### STAFF RECOMMENDATION 1027 Mansfield Avenue July 20, 2016

**Application:** New construction—addition; Partial demolition; Setback determination

**Description of Project:** Application is to demolish an existing addition, alter the front façade, and construct a rear addition. The rear addition requires a change to the side setback.

Figures 2 & 3 show the existing addition to be removed .

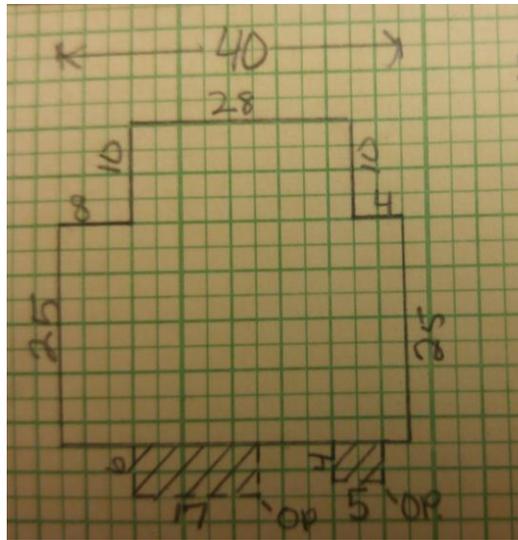
Demolition: The applicant is proposing to demolish an existing rear addition (Figures 2 & 3). The addition’s date of construction is unknown. However, it is likely that the addition was constructed between 1957 and 1968, as it does not appear on the 1957 Sanborn Map but does appear on a 1968 Property Assessor footprint drawings (Figures 4 & 5). Staff finds that the addition’s date of construction, flat roof form, materials, and fenestration pattern do not contribute to the historic character of the house or the larger Maxwell Heights neighborhood, and therefore finds that its demolition is appropriate.

Figure 6 shows the existing doorway to be removed.

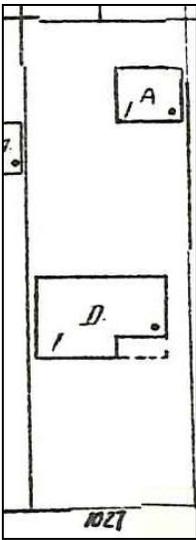
The applicant also proposes to remove a door opening on the front façade, on the right side of the façade, and to replace it with a window opening (Figure 6). The Sanborn Map indicates that this area used to be a covered porch, but the 1968 Property Assessor footprint indicates that the porch had been filled in with a front wall sometime between 1957 and 1968 (See Figures 4 & 5). The 1968 Property Assessor photo shows that the existing, secondary doorway on the right side of the front façade was

present by that time. Staff finds that the removal of the door opening to be appropriate because it is not original to the design of the house and it does not contribute to the house or the neighborhood’s historic character.

① SITE PLAN  
3/32" = 1'-0"

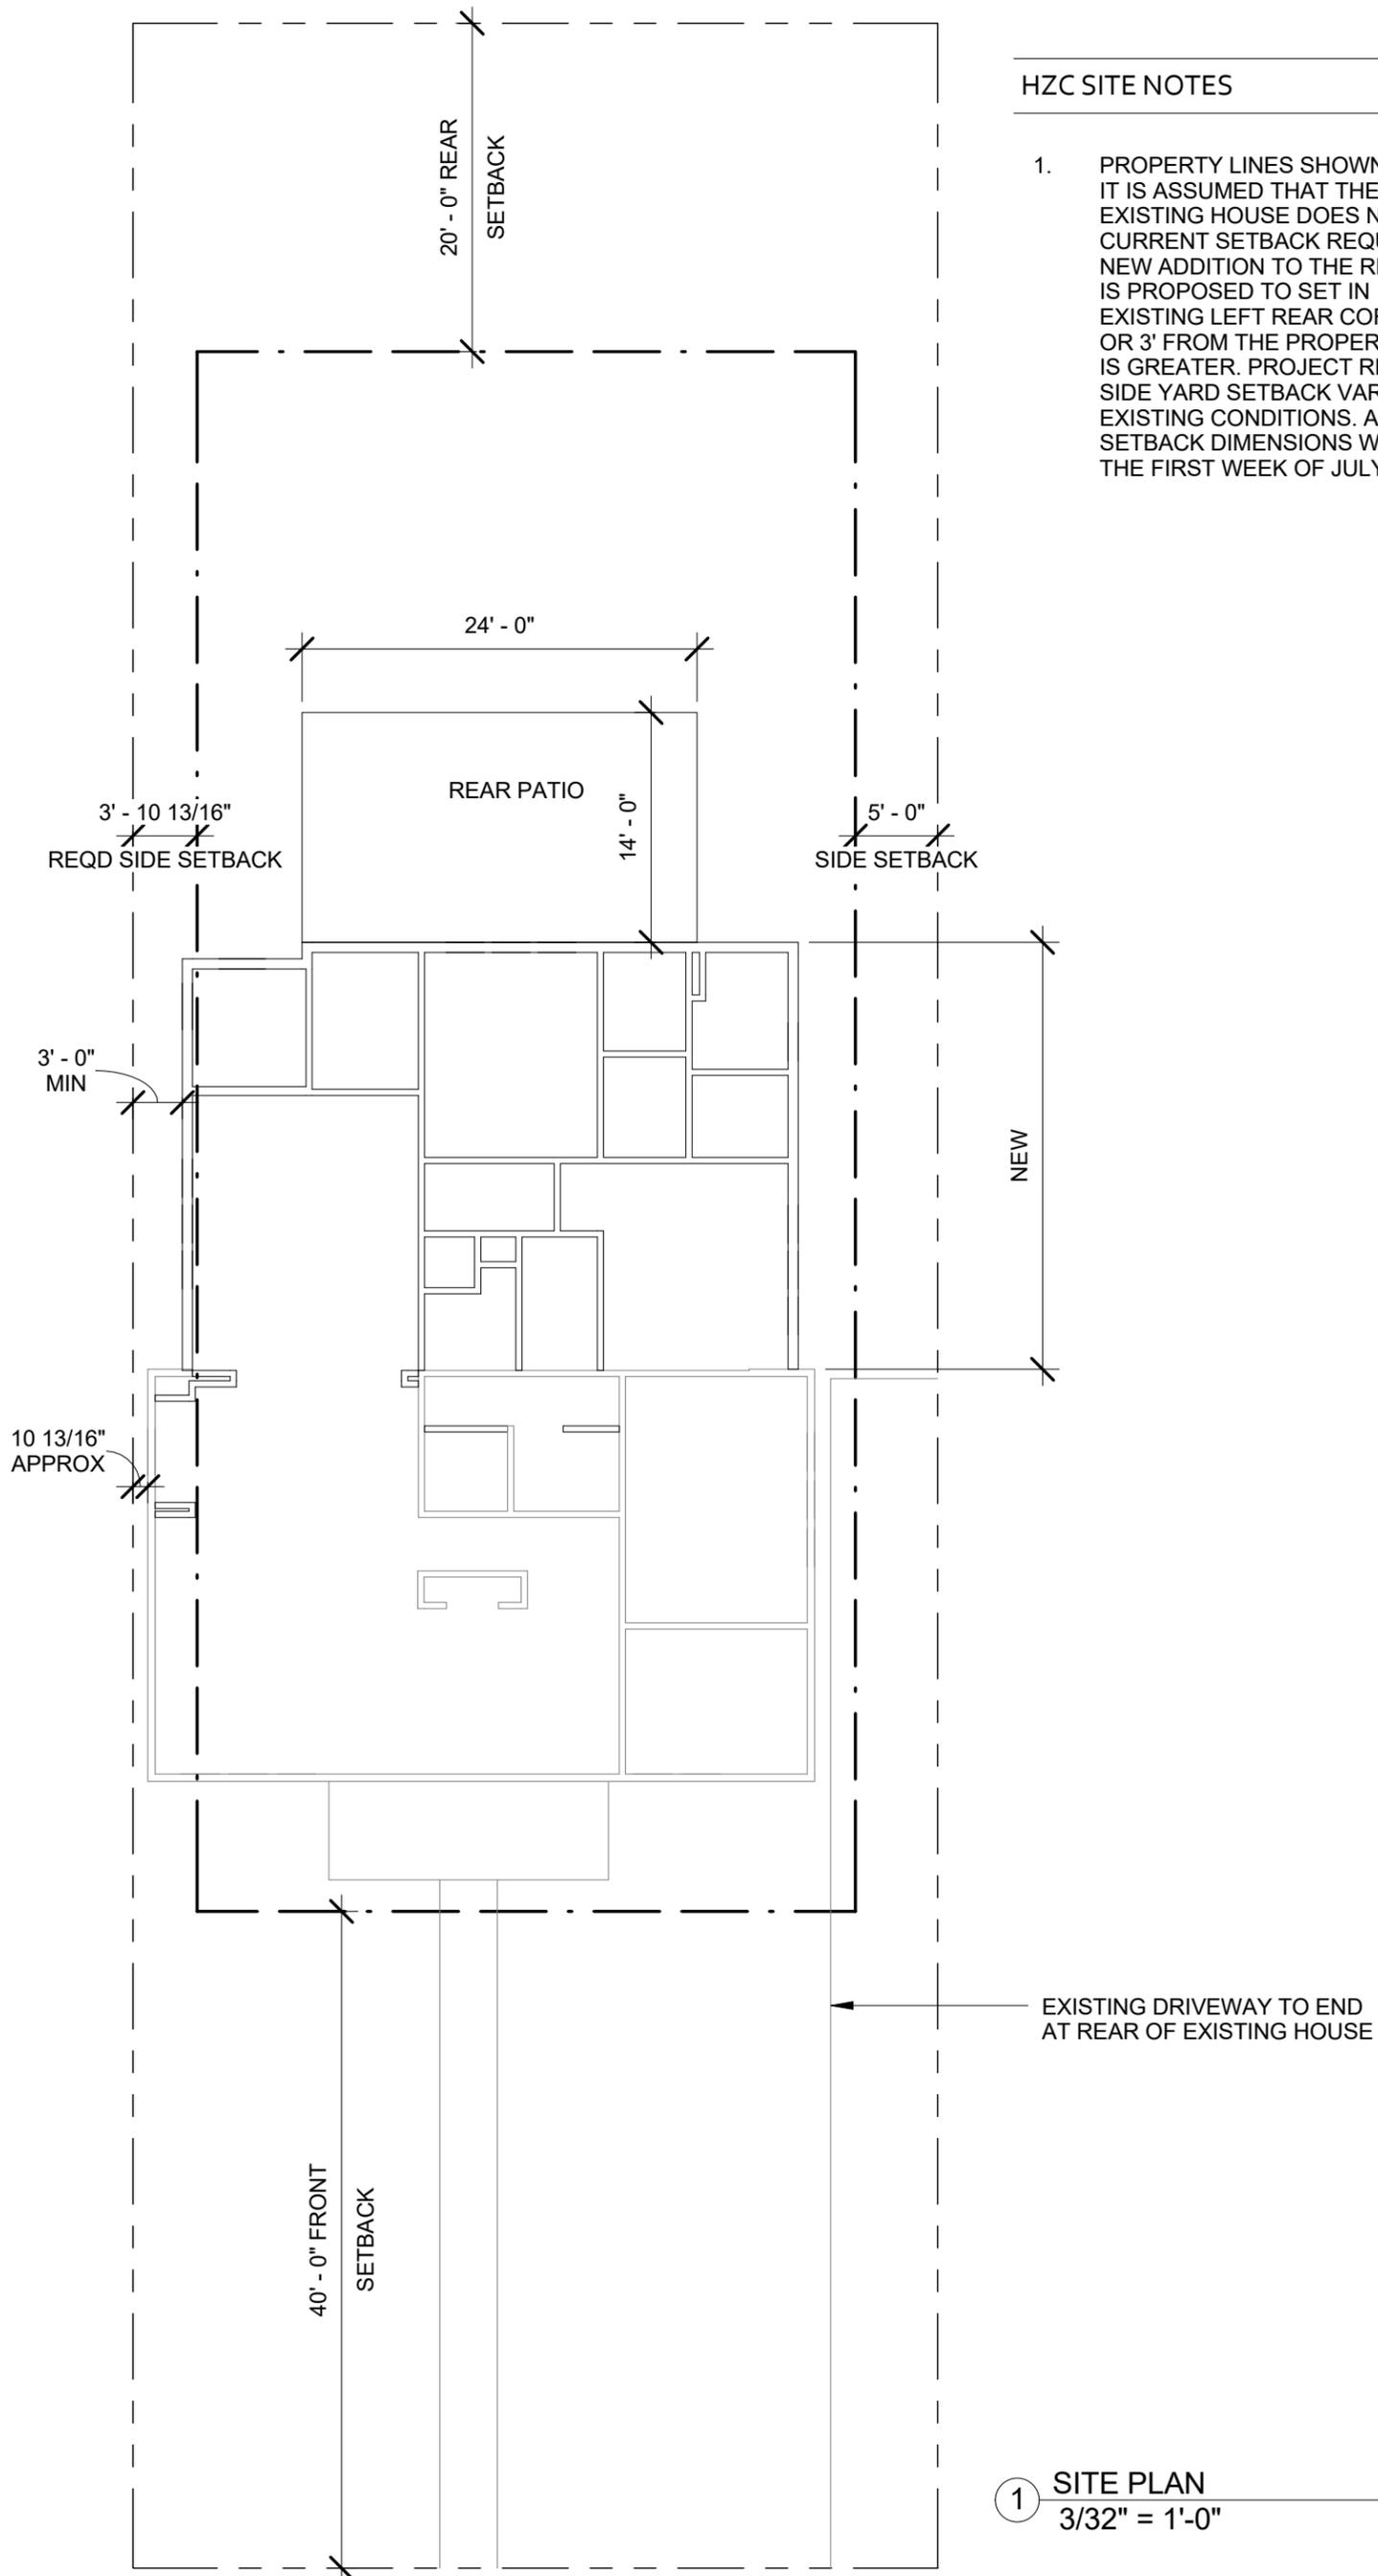
The historic house does not meet the required five foot (5') side setback on the left/west side of the house. It is situated approximately eleven inches (11") from the side property line. The new addition will also not meet the five foot (5') base zoning setback; it will be located three feet (3') from the side property line. Staff finds that the proposed side setback determination is appropriate because the new addition will not be located any closer to the side property line than the existing house. Staff finds that the proposed addition meets Sections II.B.1.c. and II.B.2. of the design guidelines
